SUBJECT: Accept the Low Bid and Award the Contract for the Construction of Grand Avenue Resurfacing and Widening Project, Community of Lakeland Village. 1st District; [\$4,523,019]; Local Funds 100%

Project Number: C4-0074

MODIFICATIONS / CLARIFICATIONS TO PLANS

17609 GRAND AVE

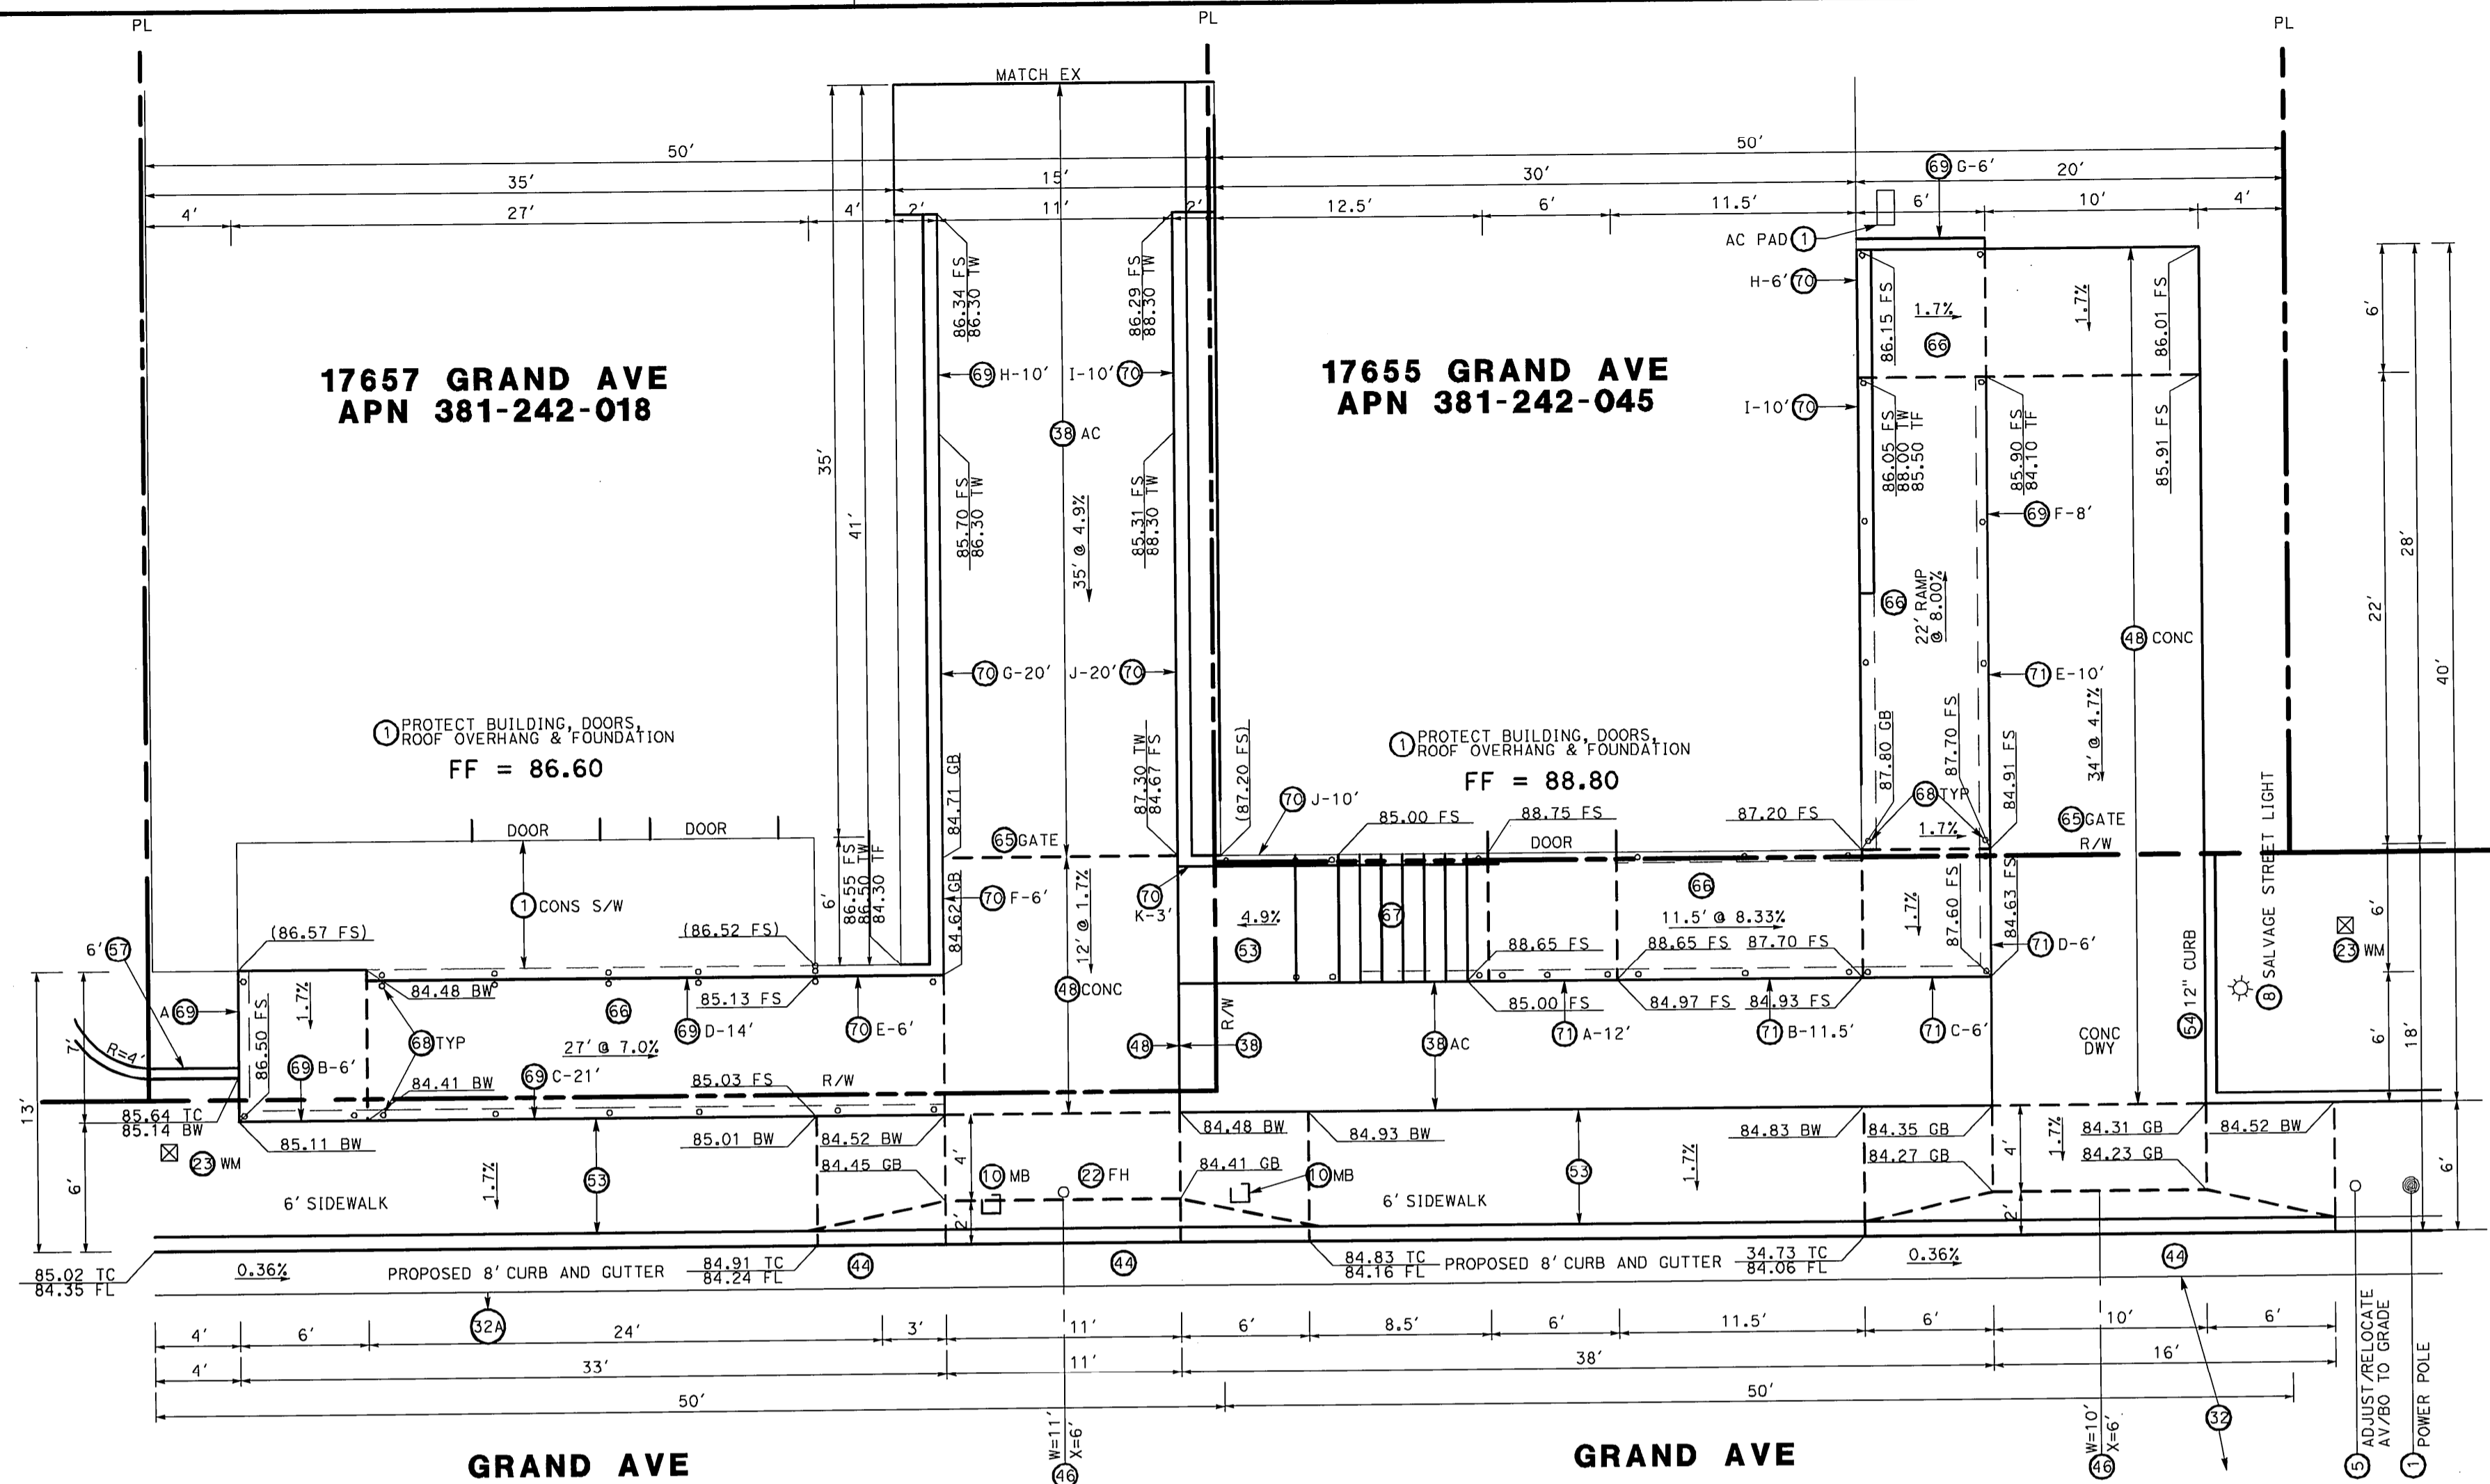
3. **Plan sheet C-2 (14 of 24)**

- Approximate Location of sewer laterals and underground utilities are added
- Construction Note 60 is revised to include "Two Grates-Perpendicular to the flow of Traffic"
- Construction Note 32 is deleted and 32A is added
- Construction Note 37 is deleted
